Development Assessment

Subject: Item 4.1 Local Planning Panel 7 May 2025
DA2024/1376 - 7 Cooleena Road ELANORA HEIGHTS

Figure 1 - Details of On-site detention

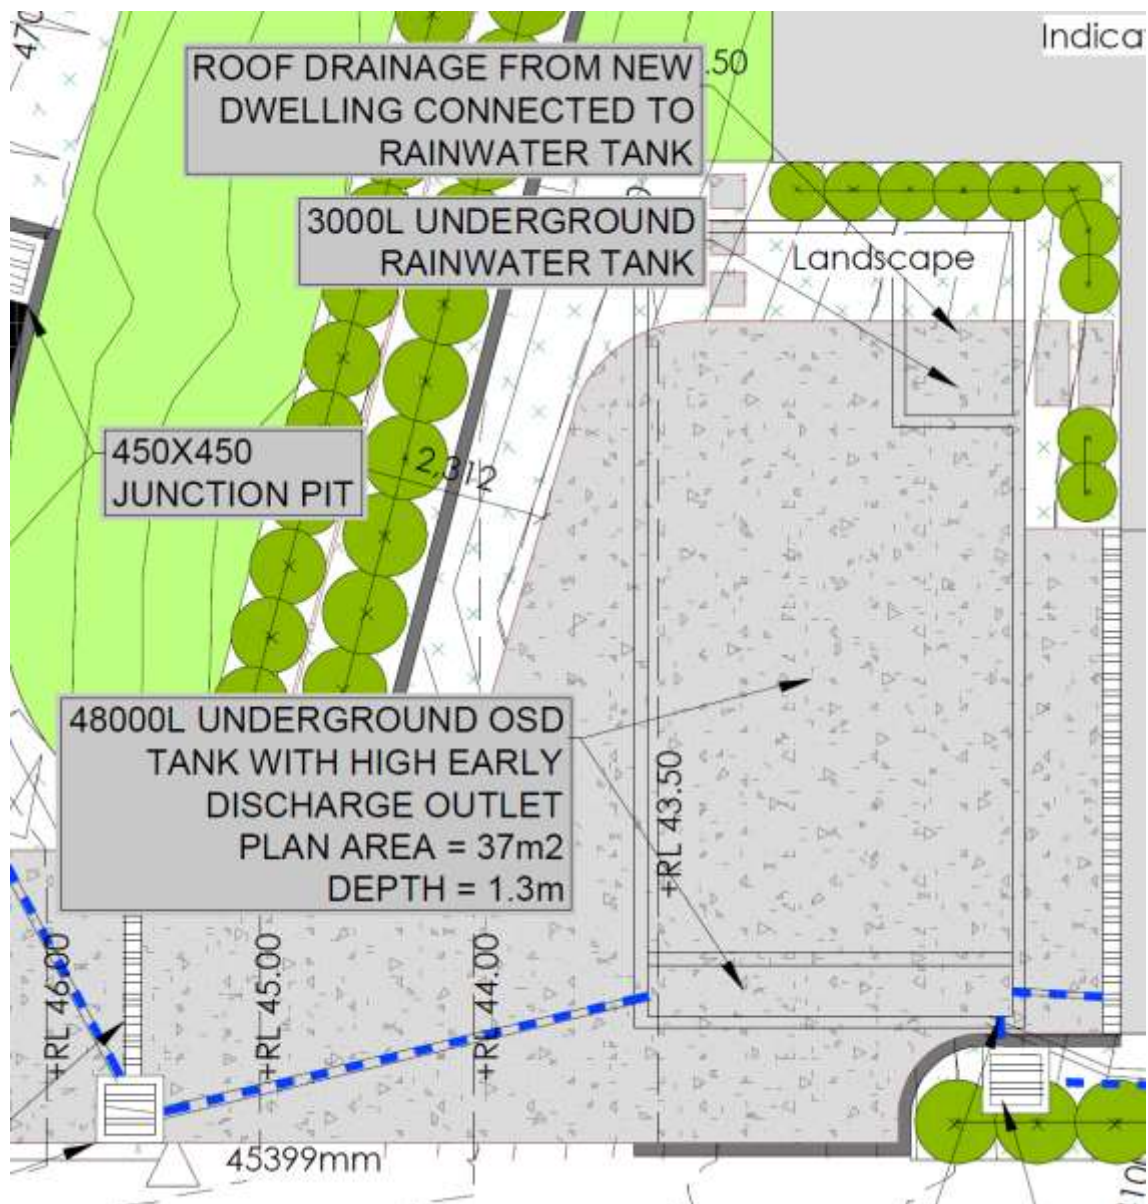
In response, Council's Development Engineer has advised that the deletion of this section of the driveway cannot be supported from an engineering perspective, stating:

The section of driveway to proposed Lot 2 cannot be deleted as the proposed stormwater tanks are under the driveway in Lot 2. The stormwater works need to be completed for the subdivision which is not possible without the access driveway. To approve the subdivision, access and stormwater disposal must be available for each proposed lot.

We would reasonably expect the driveway to be the lid of the tanks. The OSD tank is 1.3m deep and for future access of the tank it would make sense for the driveway to be the top of the tank with access grates located in the driveway.

Figure 3 - Driveway details

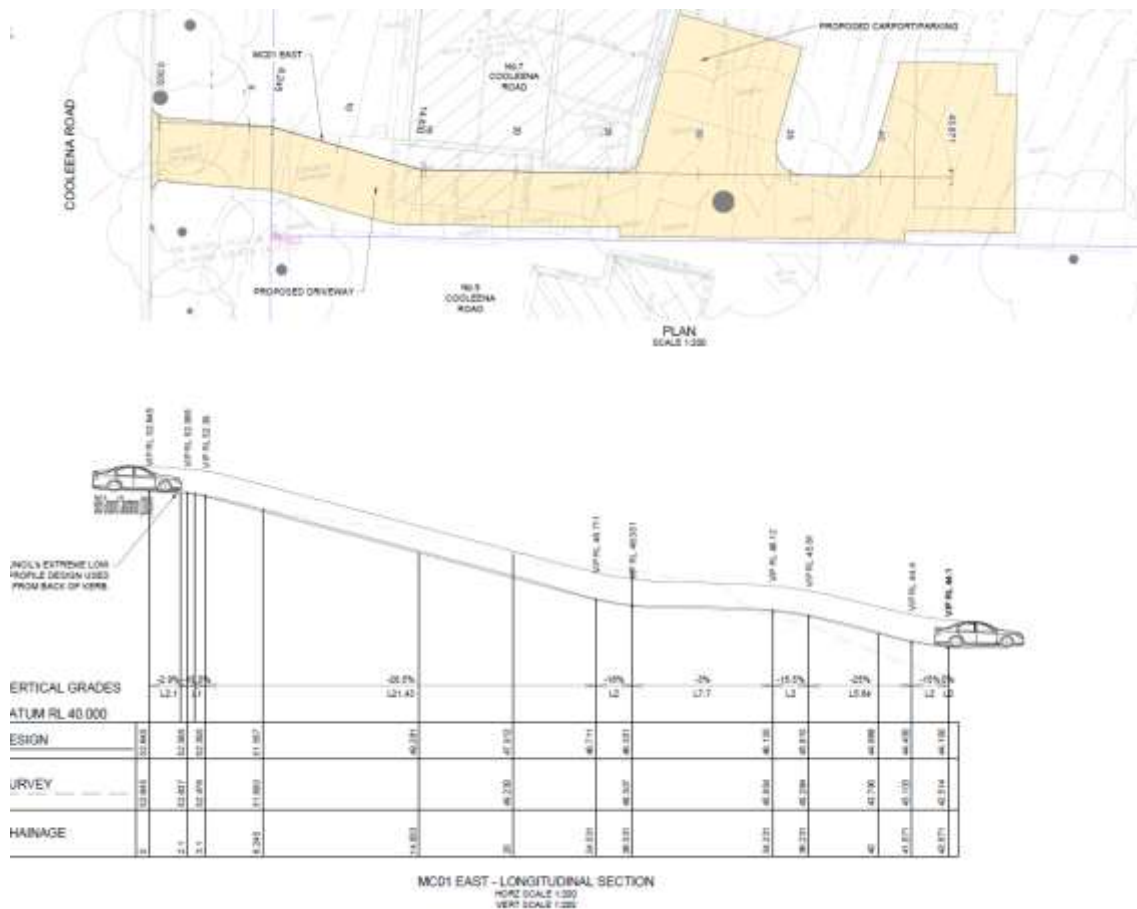
As an alternative Council has sought an amended Geotechnical Report to resolve the issue's raised with the existing driveway. An addendum letter has been submitted on 12/05/2025 by White Geotechnical Group, which has considered the section of the driveway on Lot 2 and provided recommendations for ease of construction and geotechnical integrity. Please find the letter attached.

The amended Geotech report directly addresses the issues raised by the Panel, rather than delete the section of driveway. Conditions of consent have been amended to include the updated Geotechnical Report as well as an additional condition for the entirety of the driveway located within Lot 2 to be setback a minimum of 700mm from the western side boundary to allow for screen planting.

- No approval for side and rear boundary fencing is given under this consent, as this is a matter for civil negotiation between relevant property owners. Plans are to be amended to remove reference to all side and rear boundary fencing.
- The entirety of the section of the approved driveway located within proposed Lot 2 shall be setback a minimum of 700mm from the western side boundary with screen planting provided between the driveway and boundary in accordance with the following:

- a) the selected planting is to comprise of species capable of attaining a minimum height of 4 metres at maturity,
- b) plants are to be installed at minimum 1 metre intervals and be of a minimum container size of 200mm at planting in a garden bed prepared with a suitable free draining soil mix and minimum 75mm depth of mulch.
